Manufacturer's Ref Number: CT-20-00324

Urgent Field Safety Notice **Niobe ES**

Urgent Field Safety Notice (FSN)
Niobe ES
Potential Fire Hazard

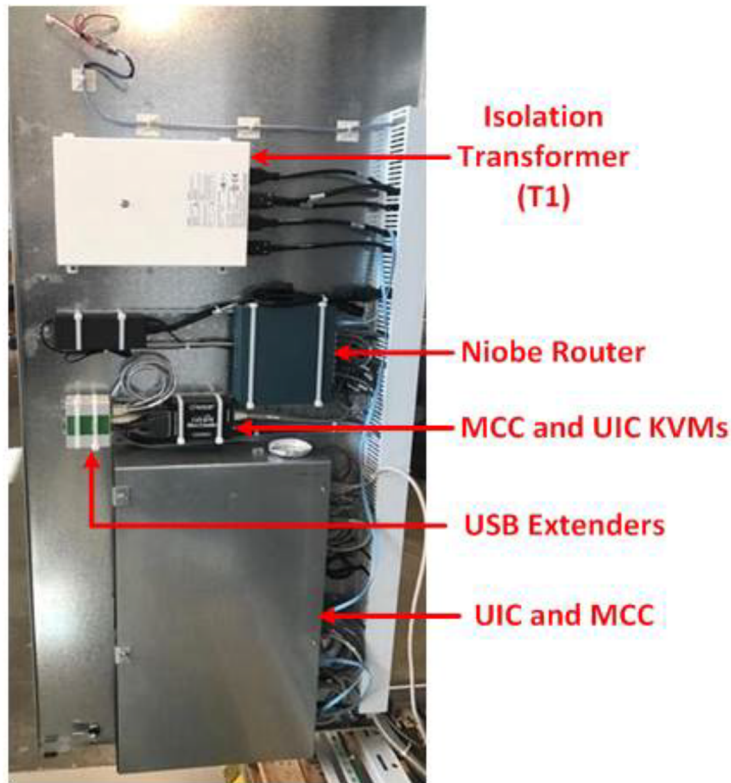
| 2 Reason for Field Safety Corrective Action (FSCA)* | |
|--|---|
| . | A SATA cable in the Niobe computer cabinet was designed in a way that could lead to electrical arcing. |
| . | Electrical arcing can cause a fire in the Niobe cabinet. |
| . | A fire in the Magnet Controller Computer was reported on 12 AUG 2020. The fire was contained within the computer cabinet and was extinguished with no injuries. It was discovered that the SATA cable inside the computer had arced, resulting in the fire. |

| 3. | 5. Action Being Taken by the Manufacturer <div style="display: flex; justify-content: space-between;"> <div> <input type="checkbox"/> Product Removal <input type="checkbox"/> Software upgrade <input type="checkbox"/> Other </div> <div> <input checked="" type="checkbox"/> On-site device modification/inspection <input type="checkbox"/> IFU or labelling change <input type="checkbox"/> None </div> </div> For systems with computers that are affected, the SATA cable will be replaced by Stereotaxis Field Service Personnel | |
